From: James Cox
Sent: 02 April 2019 08:51
To: Rob Smith
Subject: RE: Woodsmith Mine - NYM/2019/0129/NM [NLP-DMS.FID262297]

Further to your email below, please find attached final revised drawings to reflect a RAL 7016 finish on the roof.

Project: **653 York Potash**
 Drawing Title: Mining Buildings Elevation Study - Colour
 Scale: 1 : 50 @ A1
 Drwg. Created: June 2014

Drwg. No: **653-AP-0058**
 Status: **Issue**
 (Not for Construction)
 Revision: **10**

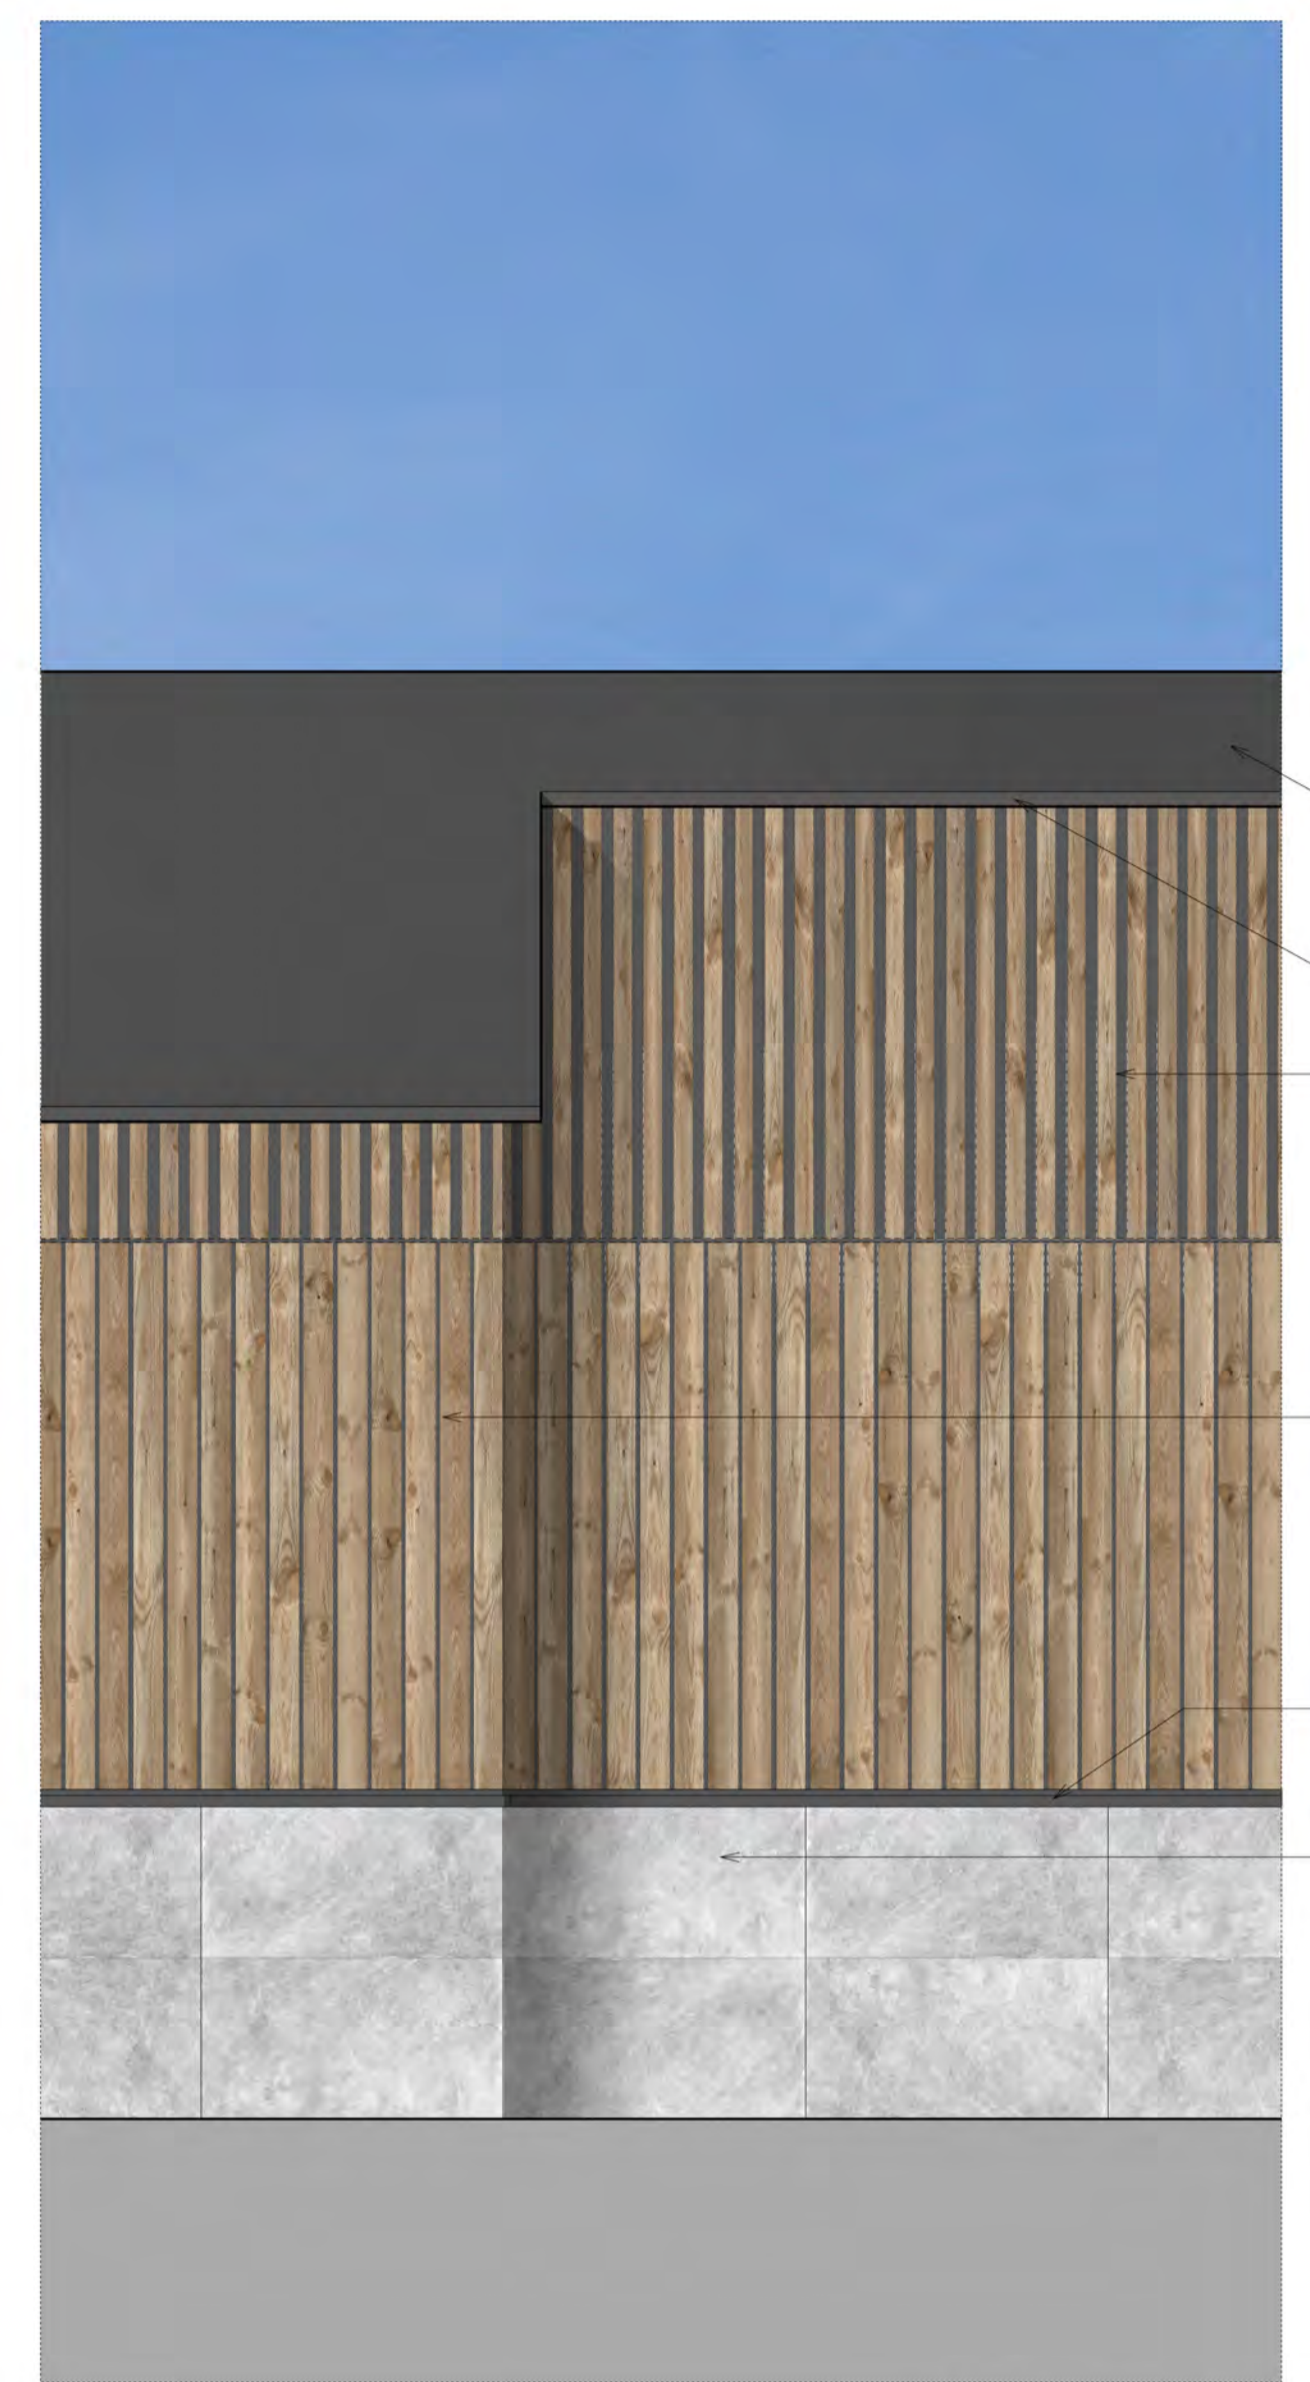
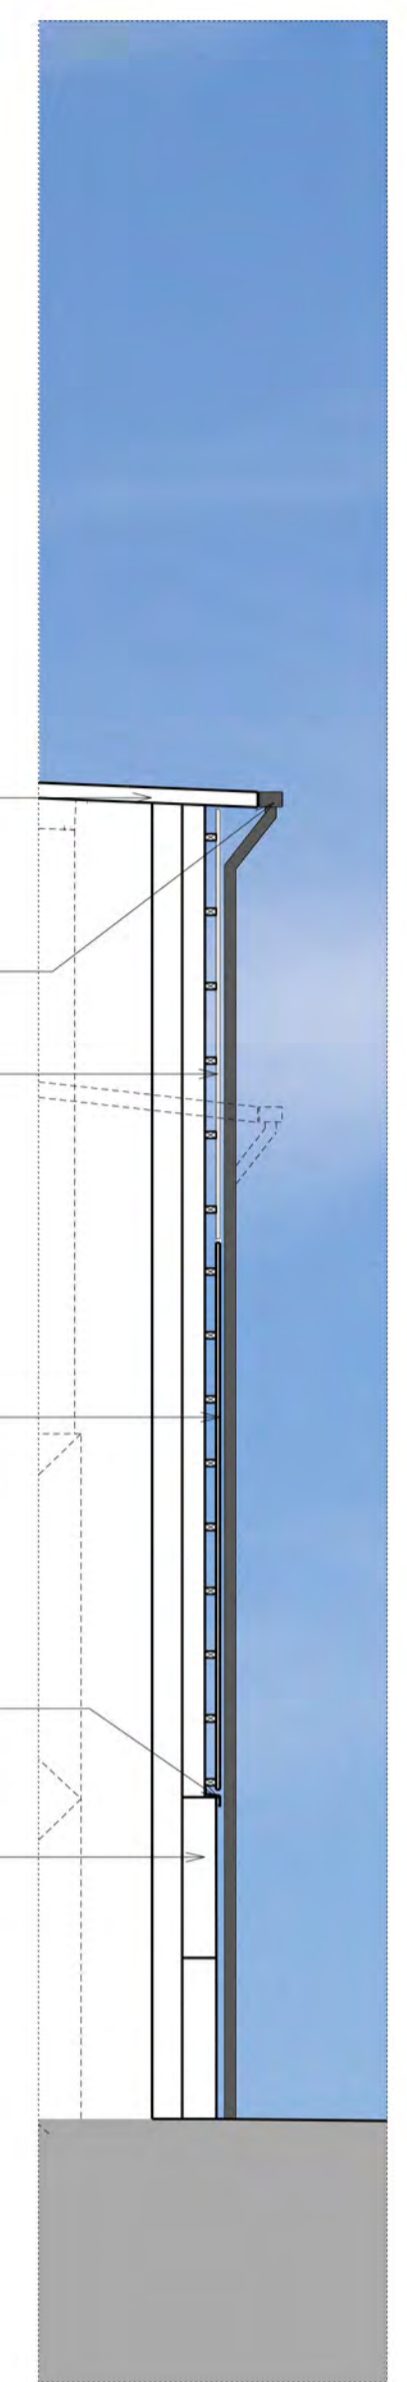
Date:	Rev:	Note:	Check:
25.09.14	0	Planning Issue	PC
11.02.15	1	Updated in accordance with NLP's Schedule of Changes for the SEI submission.	IWA
21.08.15	2	Updated cladding material following planning review.	IWA
25.09.15	3	Updated cladding detail following planning review.	IWA
06.06.17	4	Updated for Section 73 Application June 2017, in accordance with Planning Review dated 26.05.17	IWA
22.02.19	5	Updated for planning purposes	IW
05.03.19	6	Roof RAL colour amended	IW
12.03.19	7	RAL colours updated	IW
21.03.19	8	Timber cladding updated	IW
25.03.19	9	RAL colour updated	IW
01.04.19	10	Roof RAL colour updated	IW

- MATERIAL KEY**
- (M-01) Timber wall cladding (wide board & narrow gap)
 - (M-02) Concrete panel cladding
 - (M-03) PPC 'Anthracite Grey' non-reflective coated profiled sheet metal roof cladding (RAL 7016)
 - (M-04) PPC 'Agate Grey' non-reflective coated metal industrial access door (RAL 7038)
 - (M-05) PPG 'Agate Grey' non-reflective coated metal industrial roller shutter (RAL 7038)
 - (M-06) Timber wall cladding (narrow timber board & wide gap)
 - (M-07) PPC 'Anthracite Grey' non-reflective rainwater goods (RAL 7016)

DRAWING TITLE: Production Shaft Setting Out Elevations

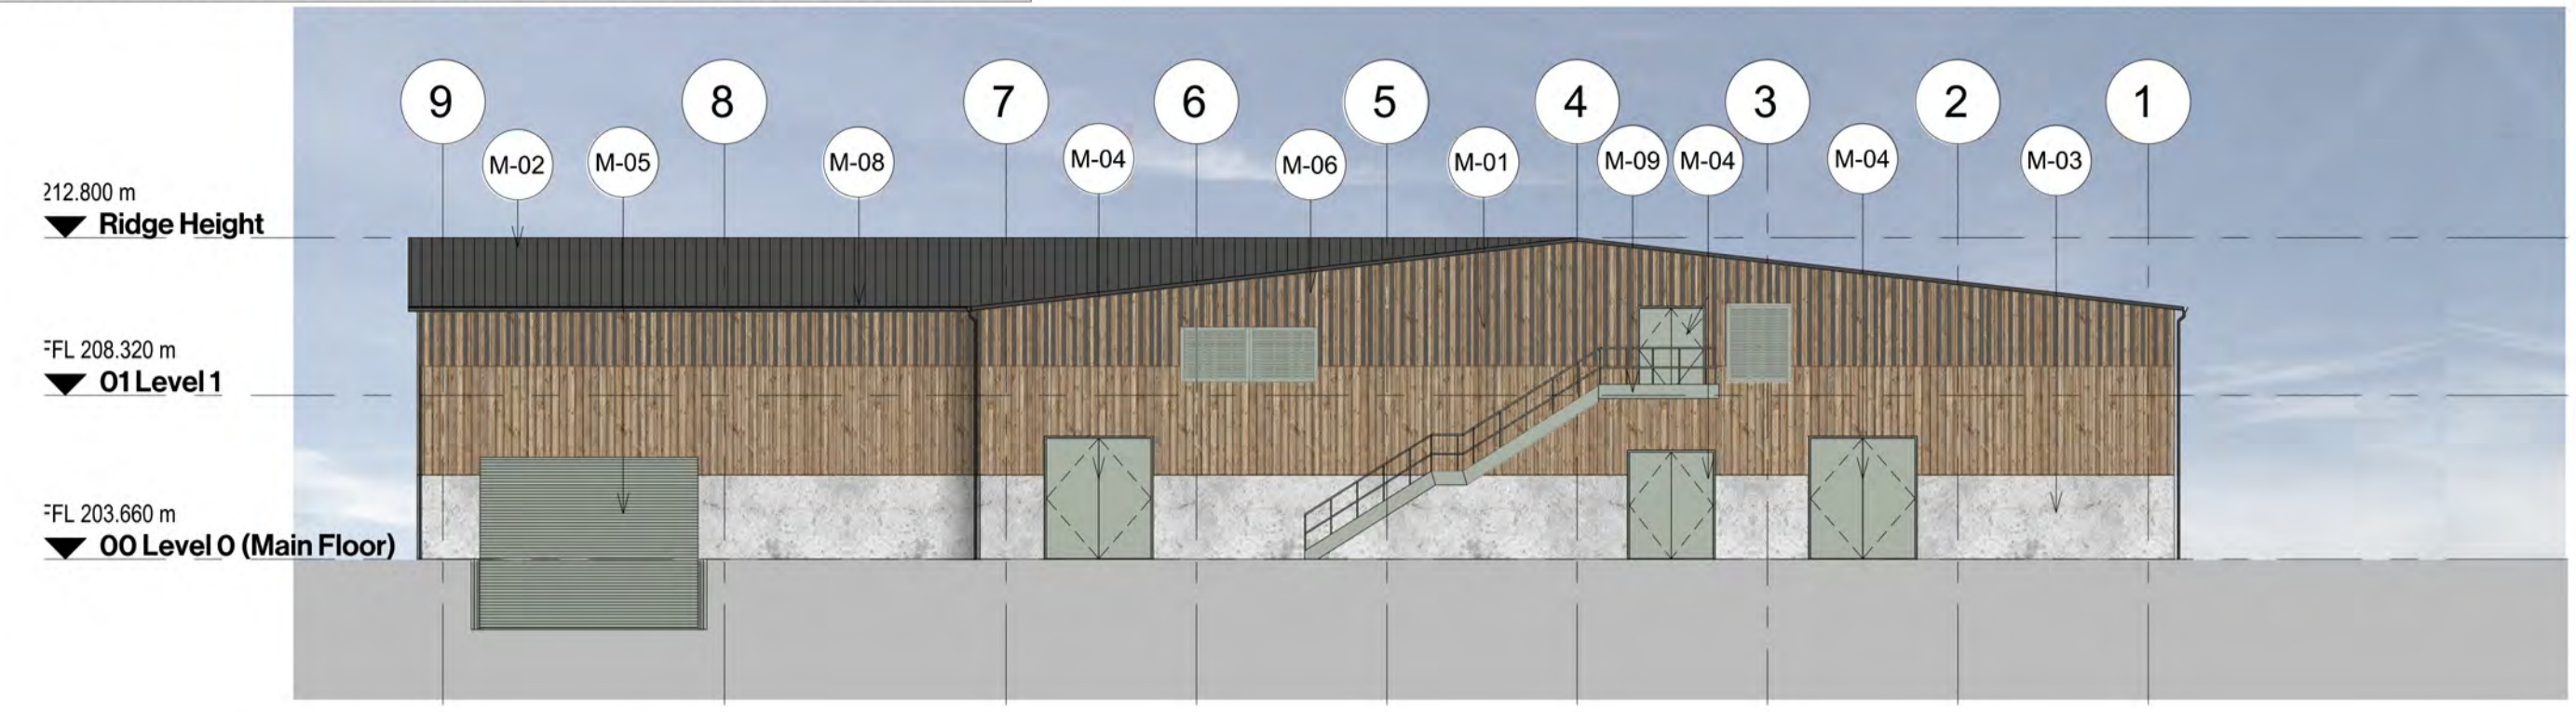
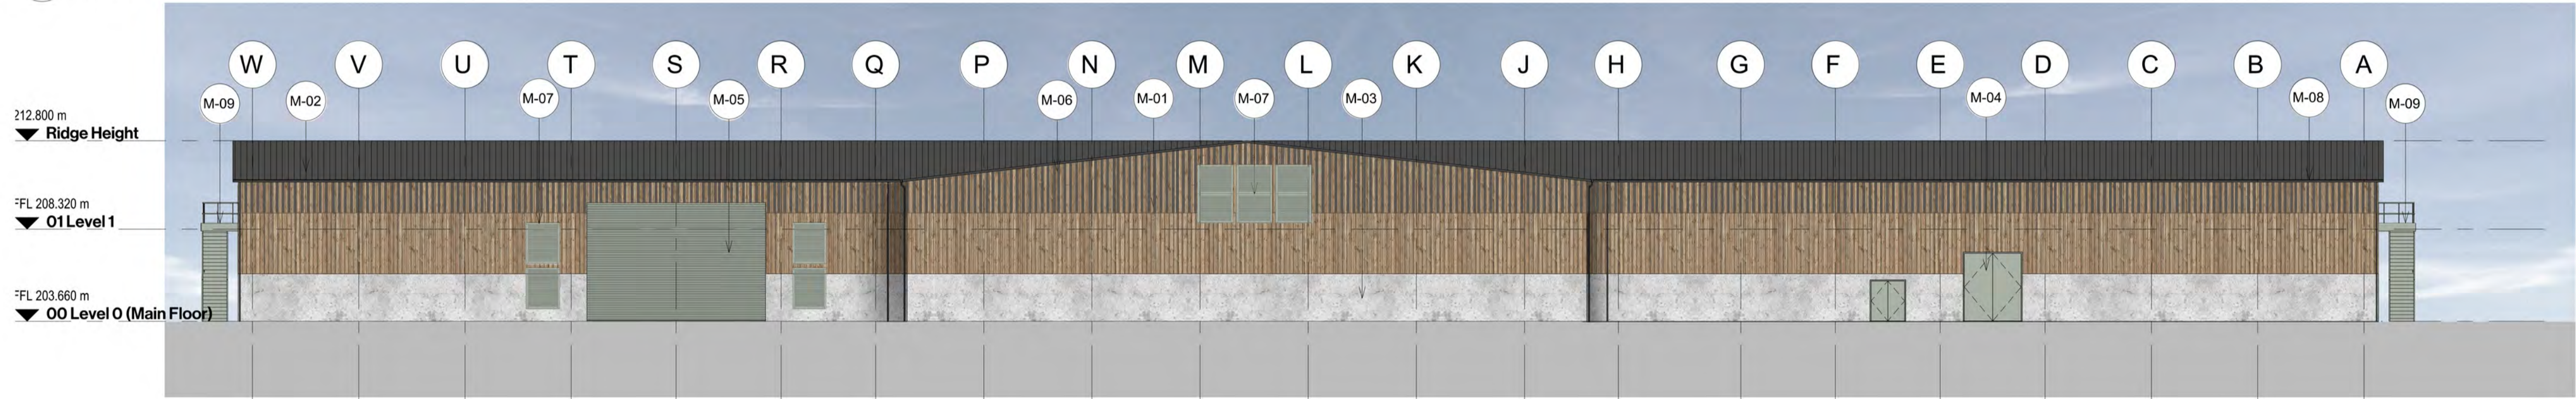
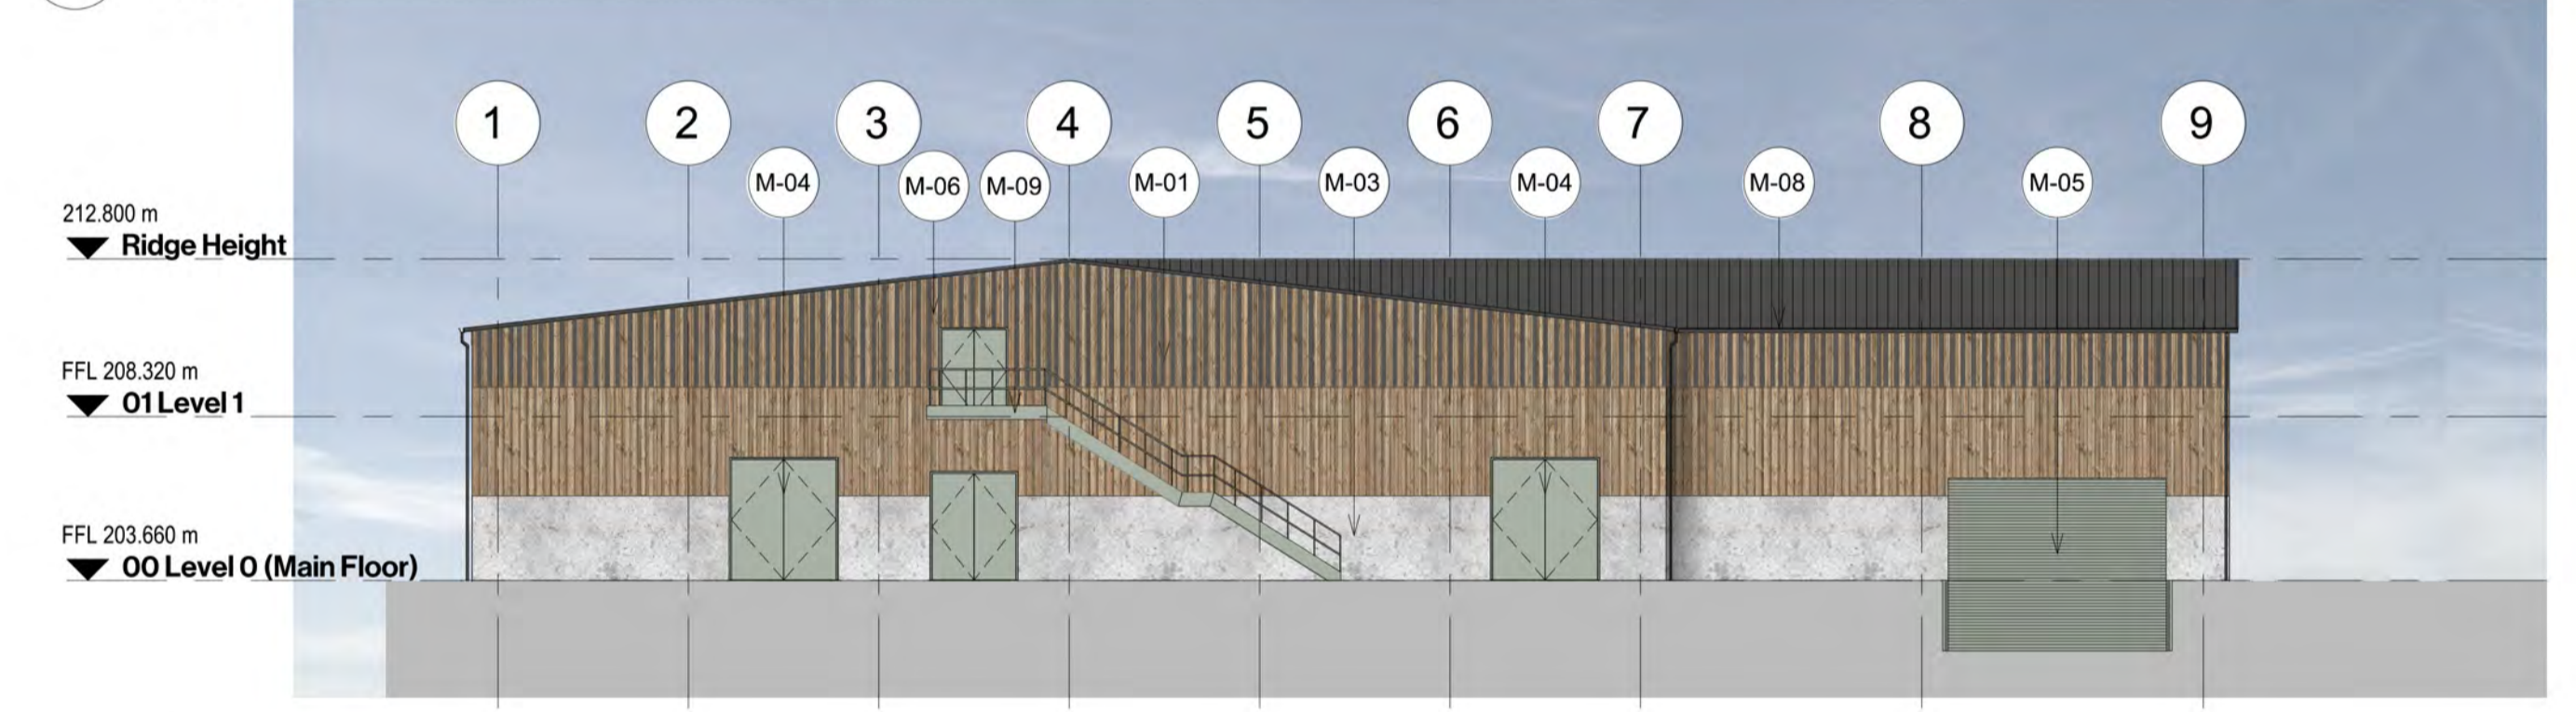
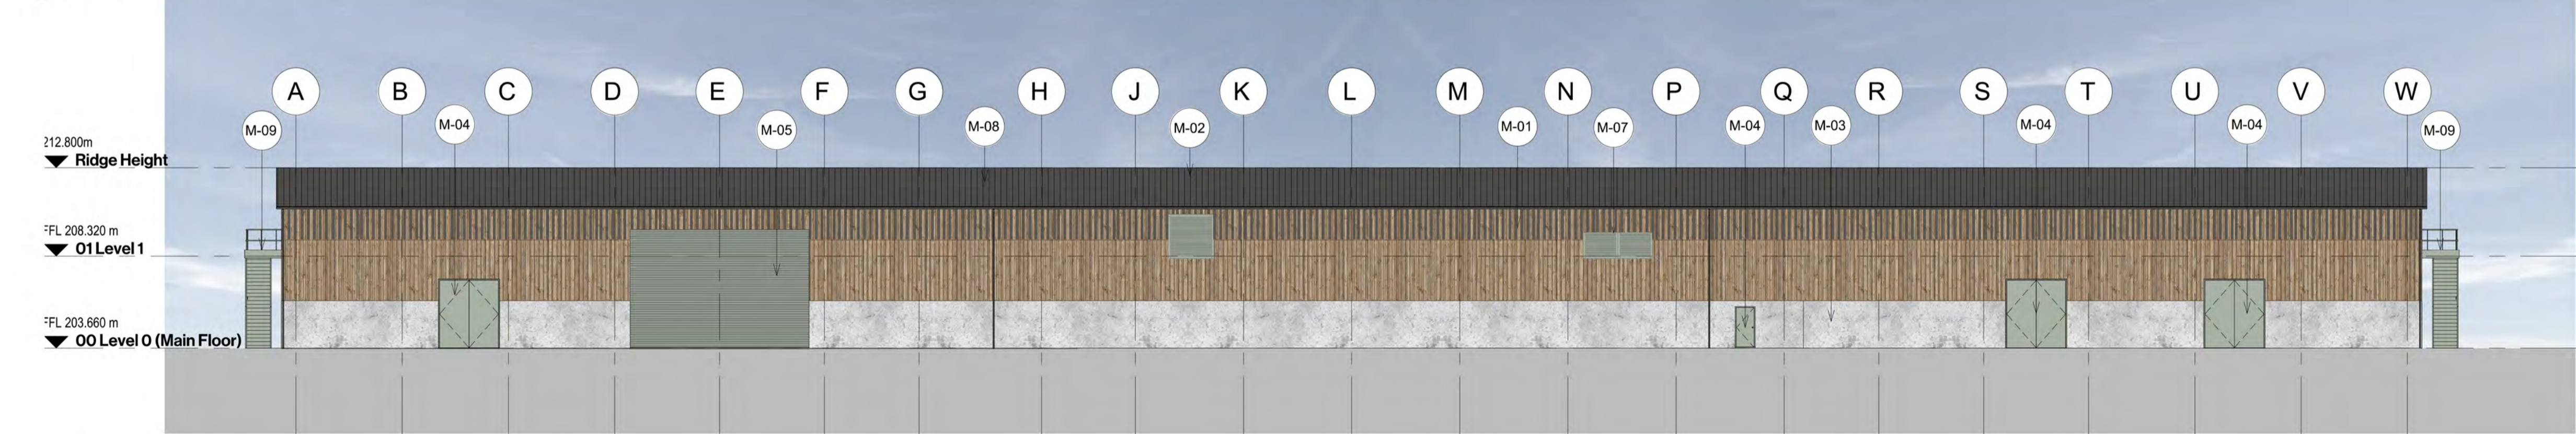
REVISION	DESCRIPTION	DATE	BY	CHKD	APPD
J	ROOF RAL COLOUR UPDATED	01/04/19	AK	JS	IW
H	RAL COLOUR UPDATED	25/03/19	AK	JS	IW
G	TIMBER CLADDING AMENDED	20/03/19	AK	JS	IW
F	RAL COLOURS UPDATED	11/03/19	AK	JS	IW
E	RAL COLOUR AMENDED	05/03/19	AK	JS	IW
D	AMENDED FURTHER TO COMMENTS	22/02/19	AK	JS	IW
C	AMENDED FURTHER TO COMMENTS	19/02/19	AK	JS	IW
B	TIMBER CLADDING AMENDED	19/02/19	AK	JS	IW
A	UPDATED TO SHOW PITCH COMPARISON	13/02/19	AK	JS	IW

- M-01 Timber wall cladding (wide timber board & narrow gap)
- M-02 PPC 'Anthracite Grey' non-reflective coated profiled sheet metal roof cladding (RAL 7016)
- M-03 Concrete panel cladding
- M-04 PPC 'Agate Grey' non-reflective coated metal industrial access door (RAL 7038)
- M-05 PPC 'Agate Grey' non-reflective coated metal industrial roller shutter (RAL 7038)
- M-06 Timber wall cladding (narrow timber board & wide gap)
- M-07 PPC 'Agate Grey' galvanised metal ventilation panel (RAL 7038)
- M-08 PPC 'Anthracite Grey' non-reflective rainwater goods (RAL 7016)
- M-09 PPC 'Agate Grey' non-reflective metal staircase (RAL 7038)
